Product Safety Recall

N202325160 Battery Cable Short Circuit

Revision: 03

Revision Description: This bulletin has been revised to include the positive battery cable replacement information. Please discard all previous copies of N202325160.

4597853

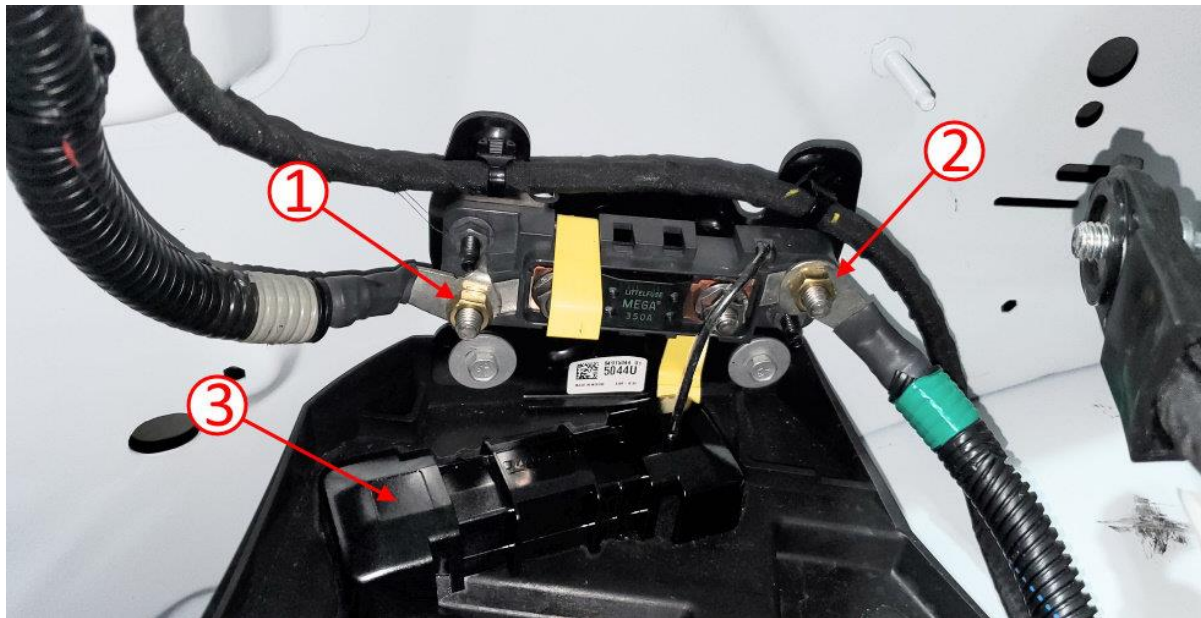
1. Remove the vehicle battery (1). Refer to *Battery Replacement* in SI.

5694188

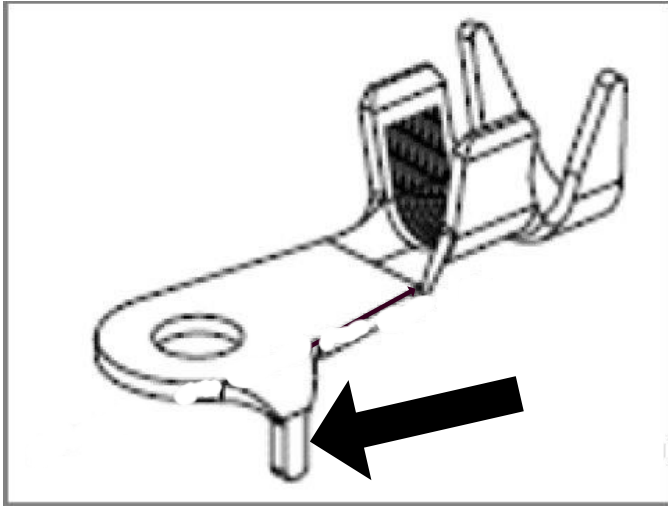
2. Locate the Mega Fuse assembly mounted on the inner fender.
3. Remove the fuse cover (3).
4. Remove the fasteners that connect the two cables to the fuse block (1 and 2).

5779095

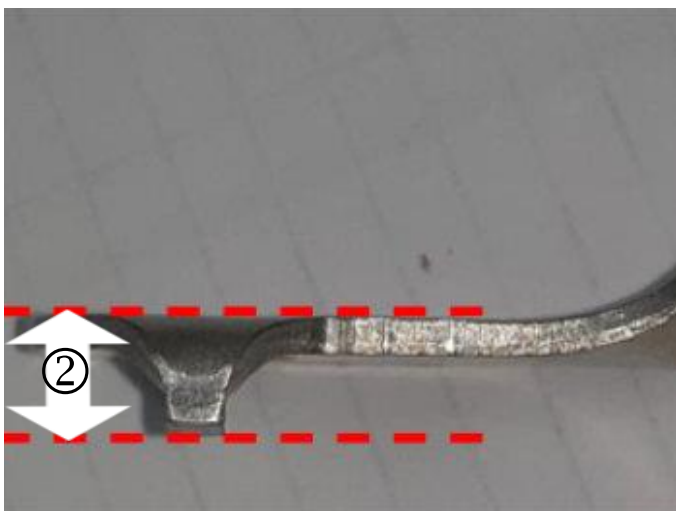
5. With the cables disconnected, locate the anti-rotation tabs on both cable ends.
6. Inspect the length of the terminal anti-rotation tabs on both cable ends.

5779103

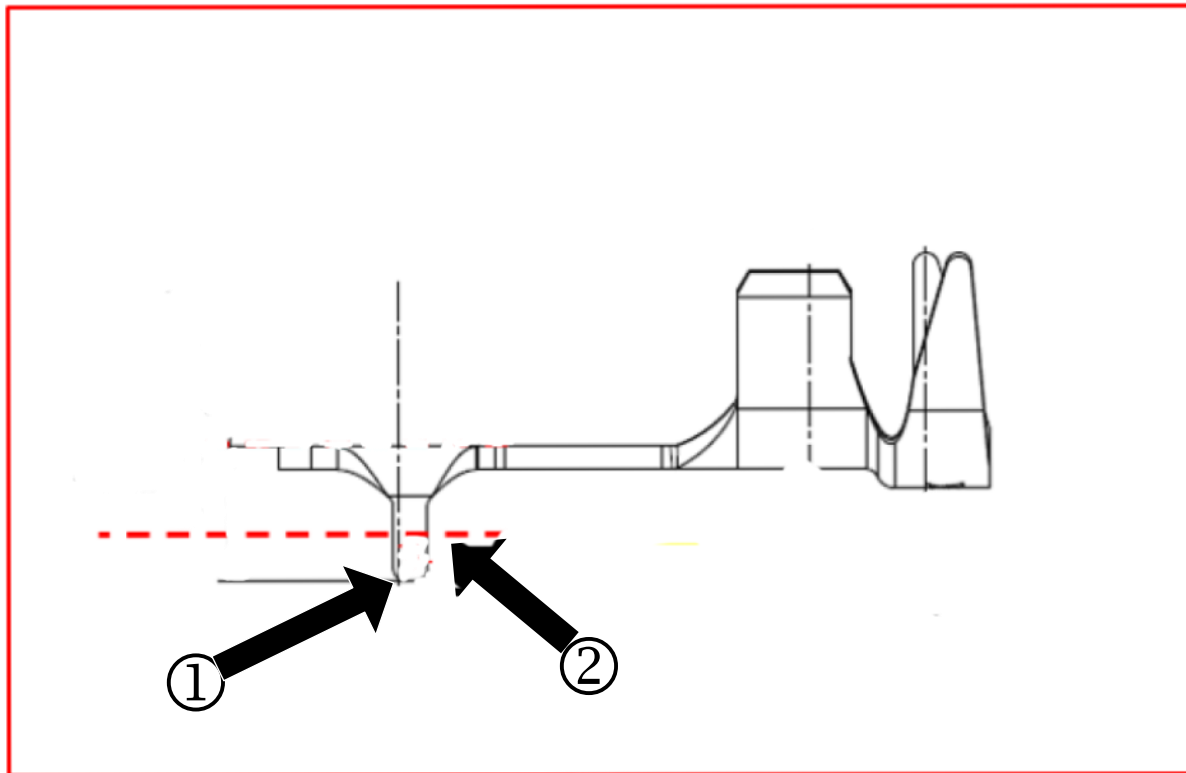
- If one or both anti-rotation tabs has been cut completely off or is trimmed to less than 6mm in length (2), the battery cable assembly will require replacement. Replace the battery positive cable, refer to Battery Positive

Cable Replacement in SI. The new service part anti-rotation tab is trimmed to the correct length, once the new cable is installed, no further action is required.

5779100

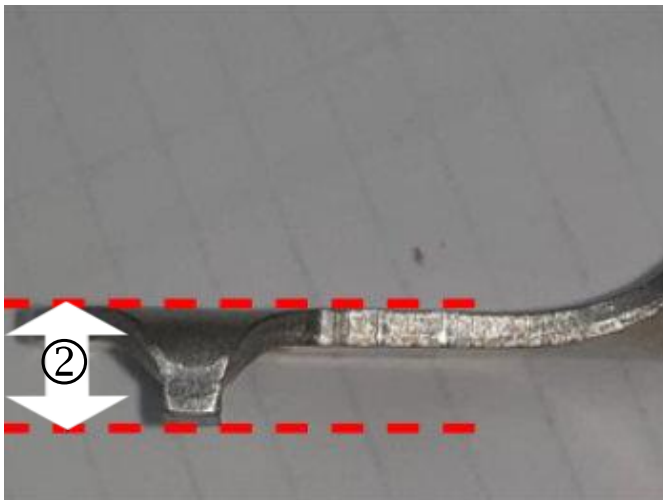
Important: The following measurement is critical to a correct repair. THE CUT MUST BE MADE IN THE EXACT LOCATION SHOWN IN THE GRAPHIC. DO NOT cut the anti-rotation tab flush. Cutting the tab flush may cause the cables to rotate and contact the fasteners or the Mega fuse mounting studs.

7. Starting from the bottom of the tab (1), measure up 4.5mm (2) from the end of the tab and scribe a line.

5779103

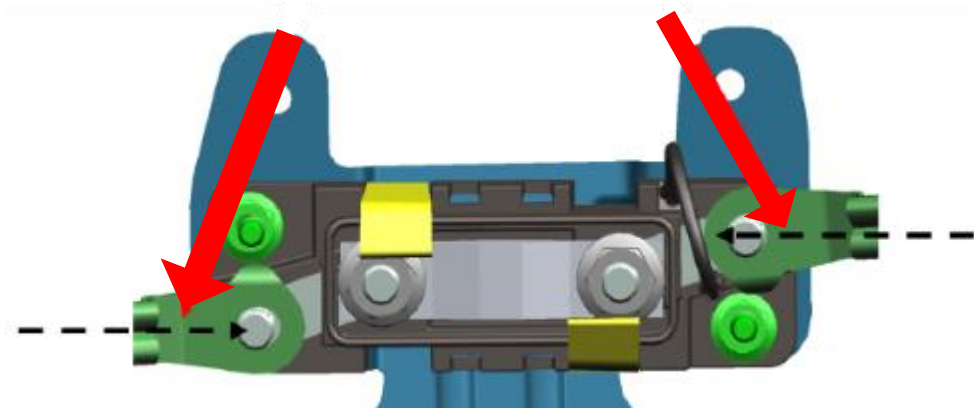
- Using cutters, cut on the scribed line. Use care to only remove the correct amount of the tab. DO NOT remove the complete tab.

- The completed trimmed terminal should have a total height of 6mm (2).
- After the tab is cut, ensure the tab is 90 degrees to the lug. Adjust as required by slightly bending the tab.
- Repeat the above steps on the second cable.
- Loosely reinstall the two cables.

5779104

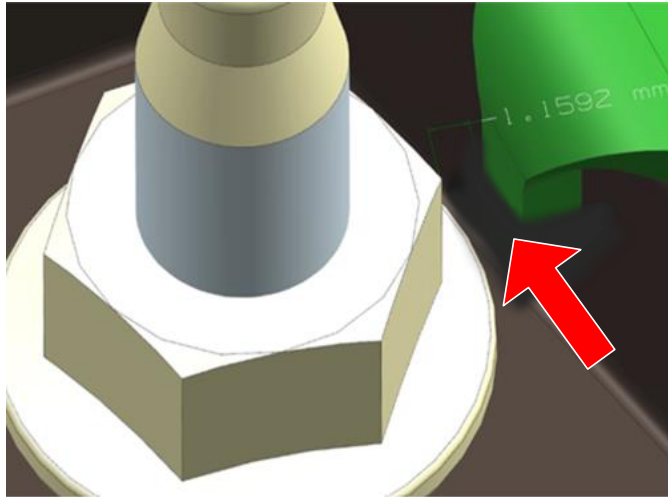
Note: When tightening the fasteners, hold the cables in a manner so they do not contact the studs as shown in the graphic above.

13. Tighten the fasteners to 20 Nm (15 lb ft).

IMPORTANT: With both fasteners tightened to specification, **make sure there is at least 1mm clearance** between the anti-rotation tab and the nut at both locations. If the clearance is less than 1mm, remove the cable and further trim the tab as required.
